**INDIANA
MICHIGAN
POWER®**

Donald C. Cook Nuclear Plant Unit 2
PROPOSED ALTERNATIVE TO THE
AMERICAN SOCIETY OF MECHANICAL ENGINEERS CODE, SECTION XI
REPAIR REQUIREMENTS
REQUEST FOR ADDITIONAL INFORMATION

Relief Request ISIR-20
Response to Nuclear Regulatory Commission
Request for Additional Information

Proposed Alternative for Preemptive Weld Overlays in Accordance with 10 CFR 50.55a(a)(3)(i)
Revision 1

Figure 1, Page 1 of 3

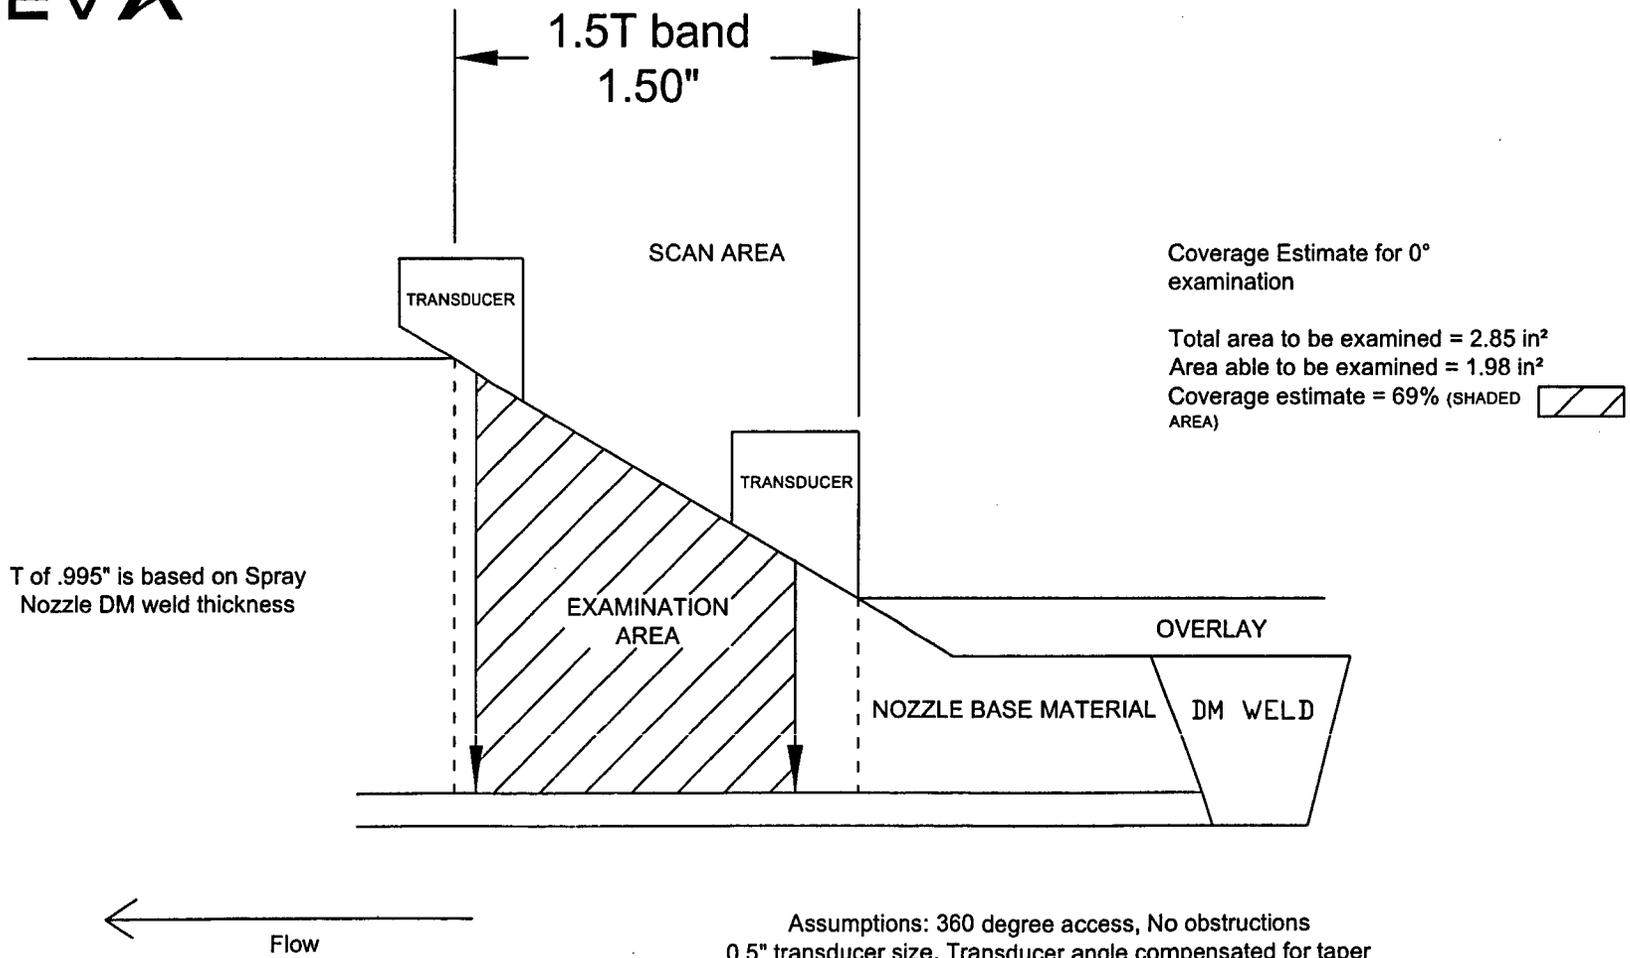
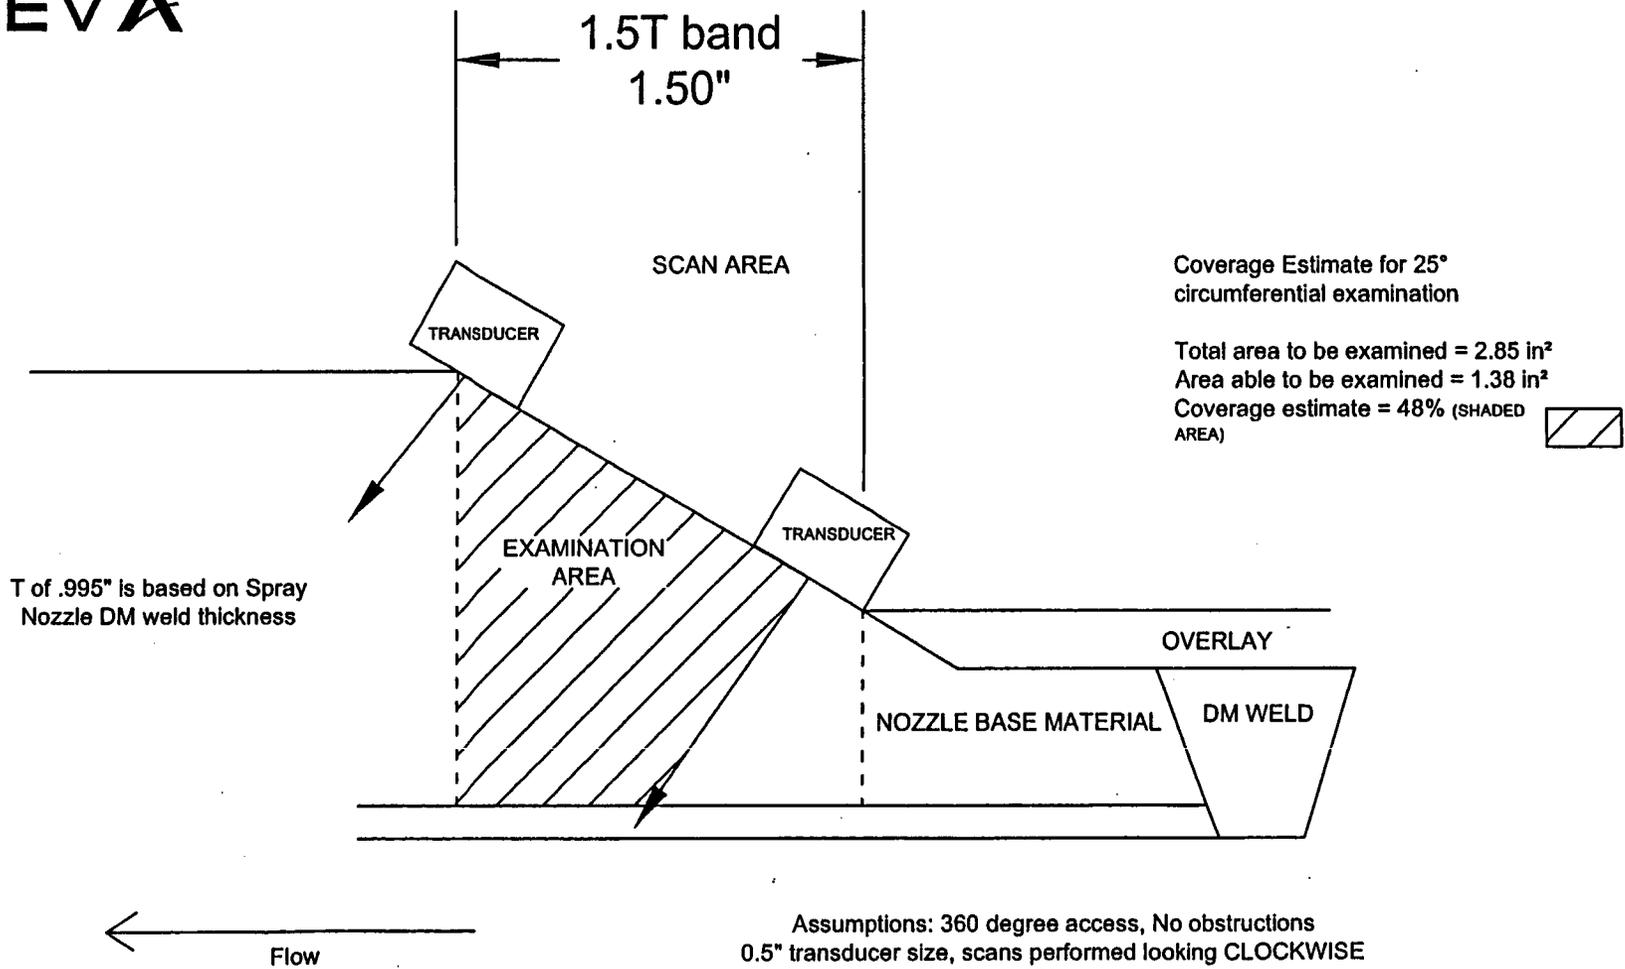
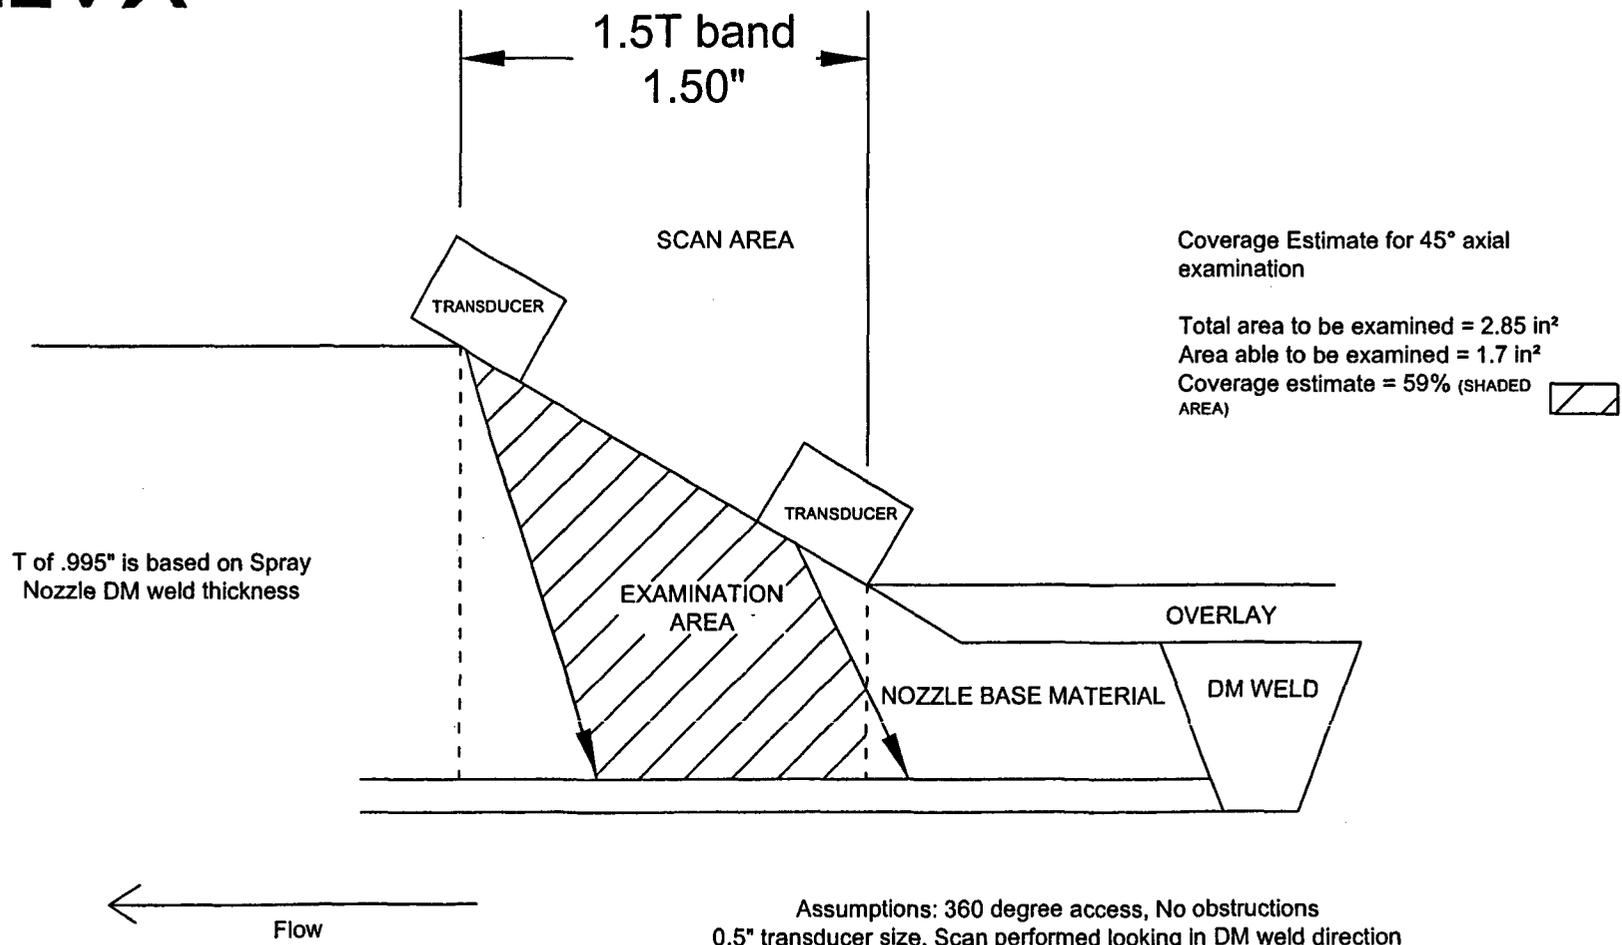
Provide additional information to support the statement that it is not possible to perform a meaningful ultrasonic (UT) examination of the 1.5T band of base material because of the existing nozzle configuration. The information should discuss the achievable amount of area that will be successfully examined for each design configuration that I&M wishes to apply a PWOL. Clarify whether the UT examination will be performed to the maximum extent achievable.

The scans that will be performed are identified in Figure 1. It is estimated that the 0-degree scan will obtain 69 percent coverage of the area, the 25-degree circumferential scan will obtain 48 percent coverage of the area, and the supplemental 45-degree axial scan will obtain 59 percent coverage of the area.
